project: **A3 DRAWING** NOTED SCALES RELATE TO A3 DRAWINGS  
**PROPOSED SUBDIVISION**

location: 9 BALLARD ST, LAKES CREEK, QLD , 4701

Letter Information Request Response Technical Memorandum – 23076LETIRRTM01

**Information Request Response Technical Memorandum  
Two Lot Subdivision (D/43-2023)  
9 Ballard Street, Lakes Creek**

**SK02[1]** Project Number  
**23076** Date  
**30/11/2023**  
**PROPOSED STORMWATER CHANNEL PLAN**

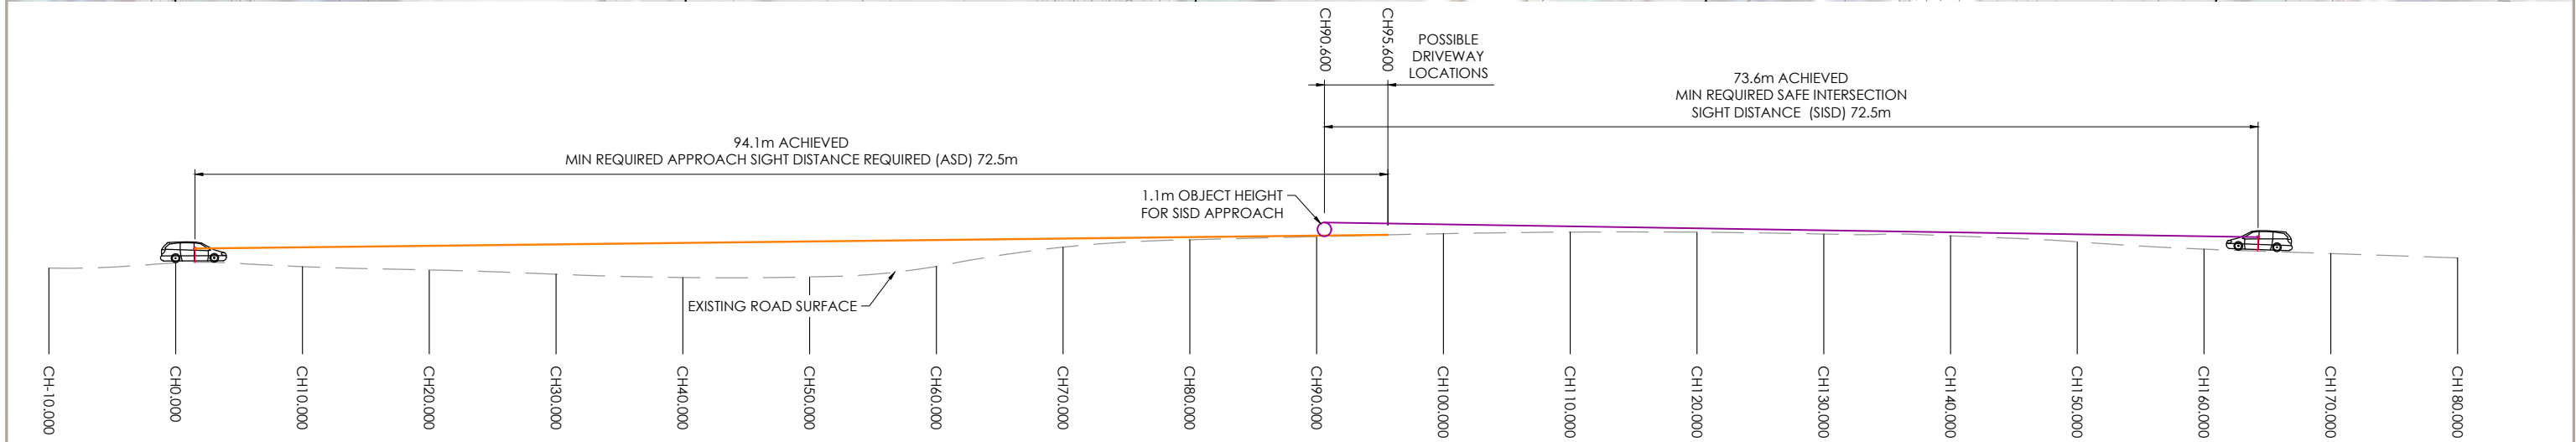
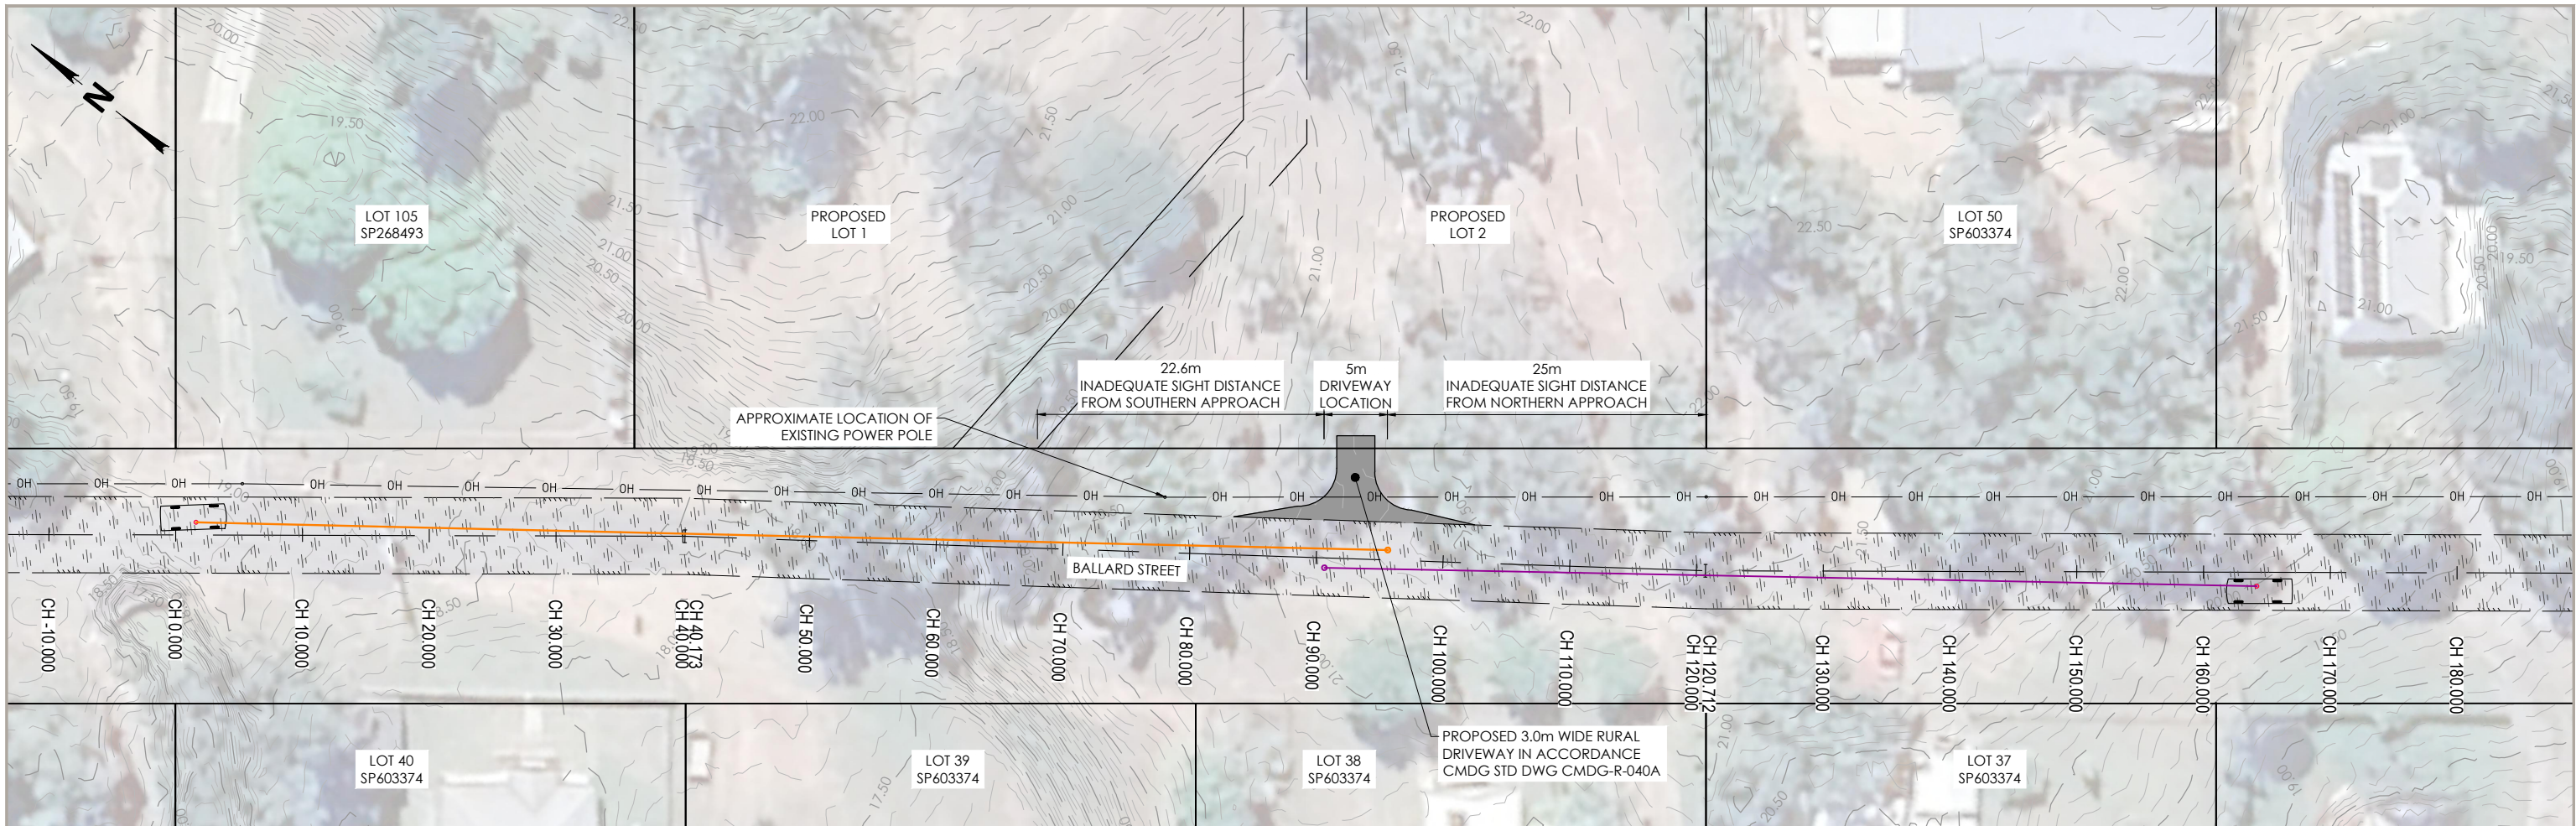
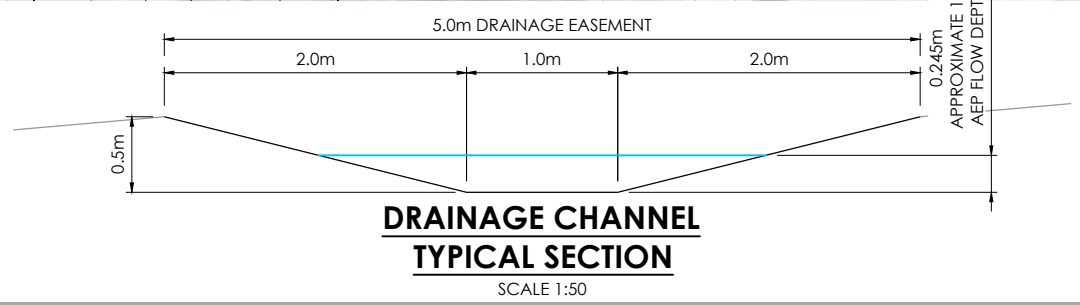
**Item 1.1 Provide and overland flow path assessment report for the subject land. Prepared and certified by a Registered Professional Engineer of Queensland, that as a minimum includes:**

Based on the above summary, a 5.0m wide easement is recommended to cover the extent of the trapezoidal channel. A preliminary layout of the proposed channel has been shown on civil engineering drawing 23076-SK02, with the drainage channel being located within an easement in Lot 2. It is expected that any proposed dwellings planned for either of the new lots will be elevated above the channel to allow positive fall away from the buildings and further increase the freeboard from the 1% AEP water level within the channel to the finished floor level of new buildings.

As determined, the proposed trapezoidal channel outlet velocity is only slightly greater than the outlet velocity from the existing gully, therefore minimising increased risk of scour at the channel outlet. Some rock protection is currently in place at the gully outlet on Ballard Street. We suggest this rock protection should remain in place with the proposed trapezoidal channel, with final channel and outlet details to be refined as part of further detailed design stages of the project.
